My Viewpoint
Bill Grant

To; Auburn Planning Commission & City Council
Re; Baltimore Ravine Access Alternatives

B.R.S.P.
Alternative Access Locations
Herdal Drive - # 1
Indian Rancheria Rd - # 8
West of Thousand Oaks - # 9

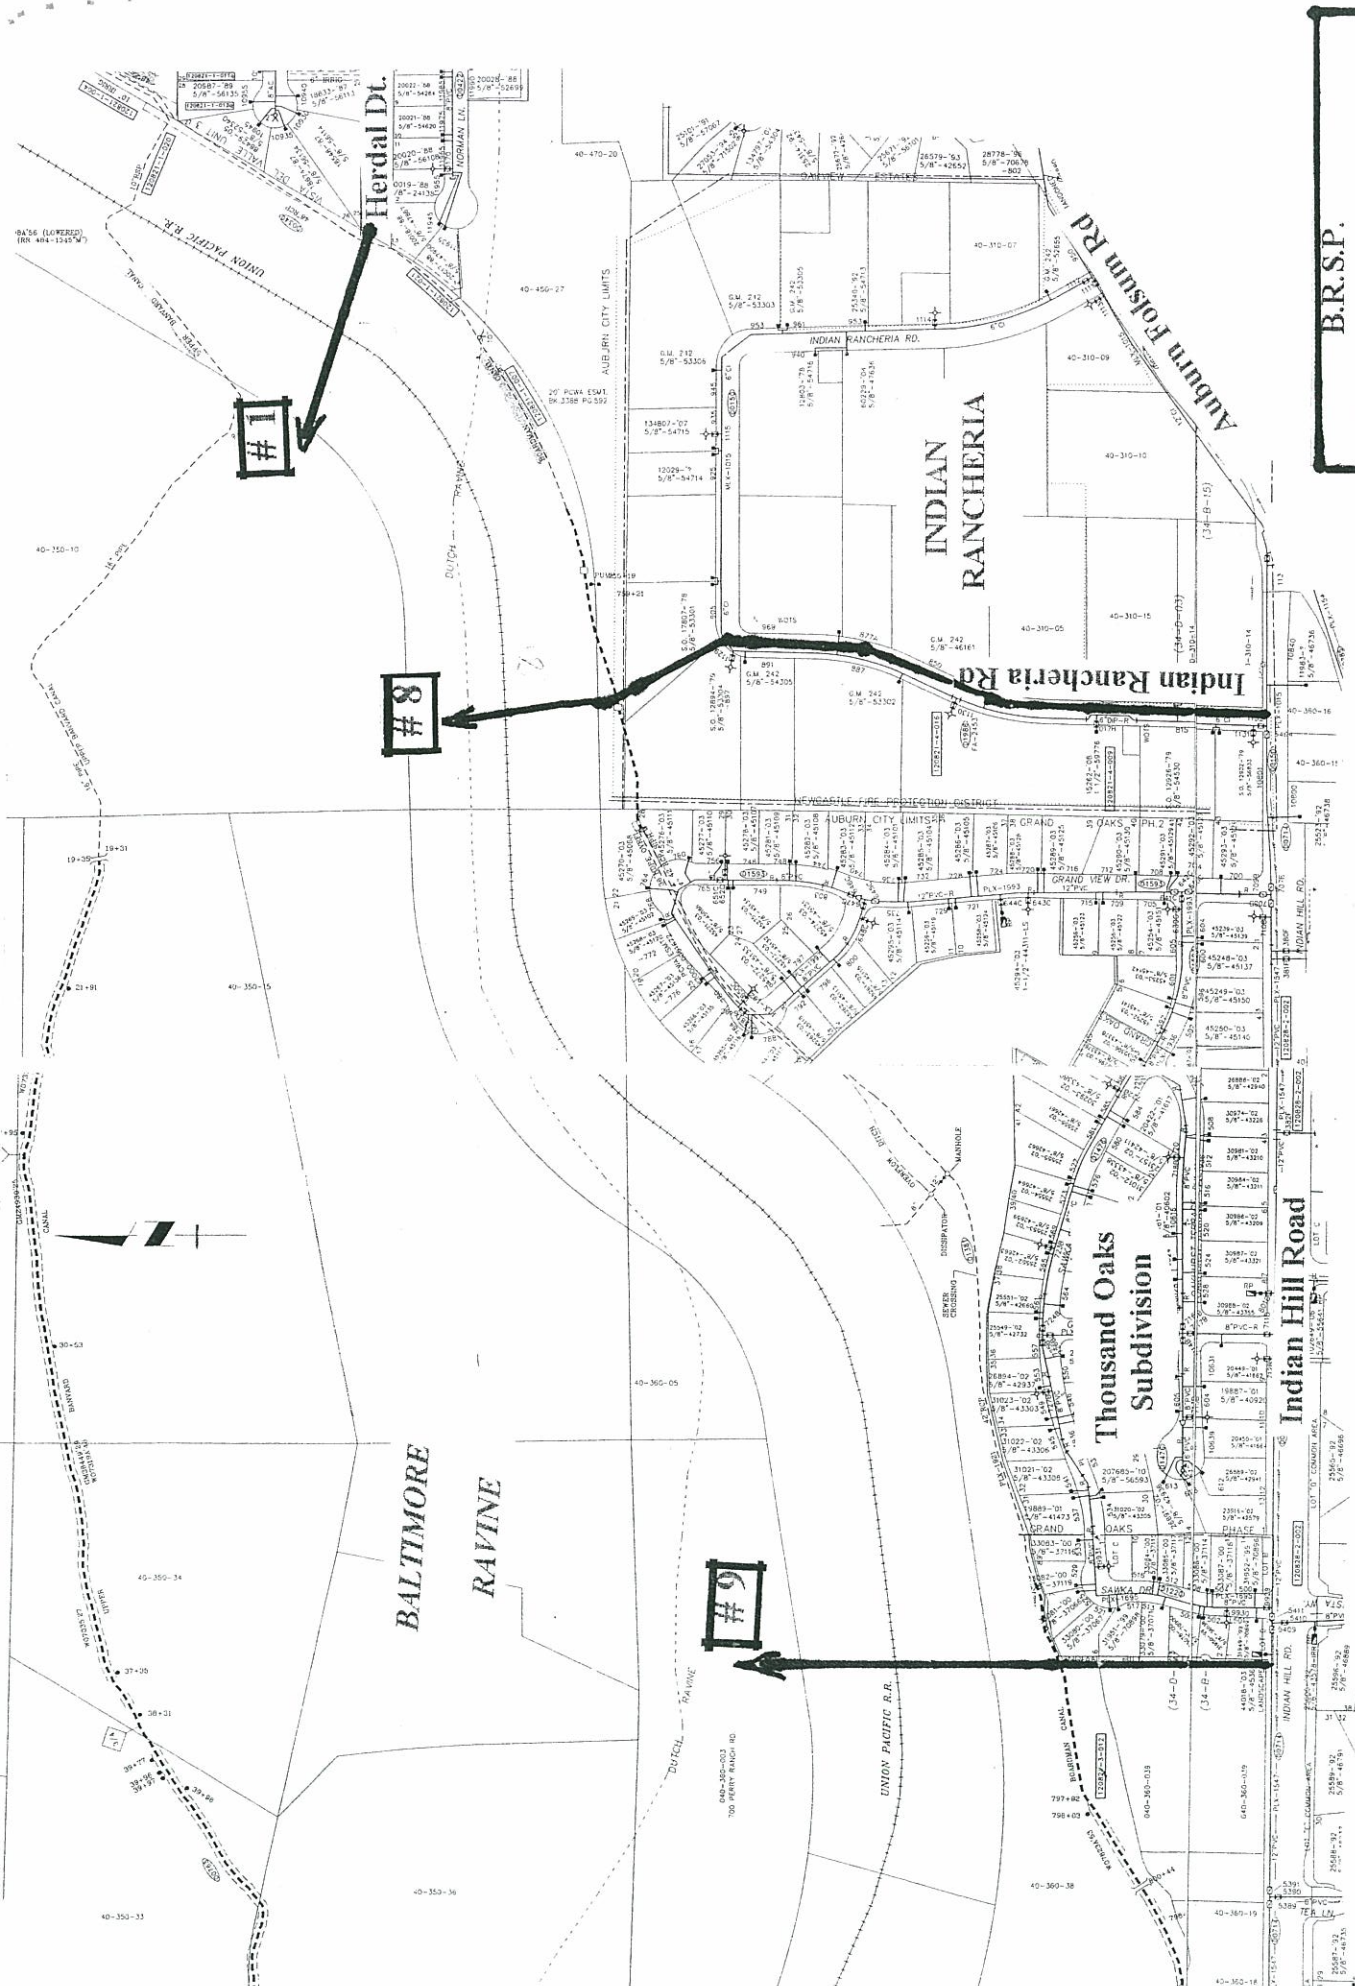
However the authors of the EIR were remiss in failing to specifically identify three other options. These are located at Baltimore Road, Indian Rancheria Rd and Indian Hill Road – west of the Thousand Oaks Subdivision. I have assigned these sites #7, #8 and #9.

#7 -Baltimore Road This is an existing private road off Palmyra St. It originally served a Ranch in Baltimore Ravine. Now there are 4 or 5 homes along this road, as well as a small 7-8 lot subdivision on Knollwood Drive, which branches off of Baltimore Road. It would be a challenge to upgrade this road to City standards. But this is the ONLY route into Plan Area 1 that does NOT cross the railroad. No railroad bridge required !

#8 - Indian Rancheria Road This option would utilize about 1000 feet of the west leg of Rancheria Road off of Indian Hill Road. About 10-12 subdivision lots would be impacted along this length. From there a new route would traverse northerly between two lots and across the railroad. I have no information on the terrain in this area..

#9 – Indian Hill Road. This option starts at Indian Hill Road, and runs parallel to the westerly boundary of the ^{Thousand} ~~Auburn~~ Oaks subdivision. It would continue northerly and go across the Railroad into the Ravine, ending somewhere in the vicinity of the Perry Ranch Road. This location would probably require about 1,000 feet of roadway; but I have no information on the terrain. The effect on existing residents appears to be minimal.

I believe that the City officials should seriously review these additional options, before adopting and certifying the EIR. I would also suggest that consideration be given to substituting an Indian Hill access option for the Werner Road / Ophir Drive location. The Werner Road route is an inadequate, awkward, unsafe and misguided choice. It will lead to problems and difficulties to implement and maintain. And it still would not provide a safe, convenient and suitable route in or out of the Baltimore Ravine. The BRSP area would be better served with both an access off Indian Hill Road (#8 or #9) and access at Herdal Drive or one of the other nearby options (#4, #5, #7). I strongly urge Auburn to adopt this plan, or a similar one with dual access locations excluding the Werner / Ophir Road route. These various options are shown on the two attached maps.
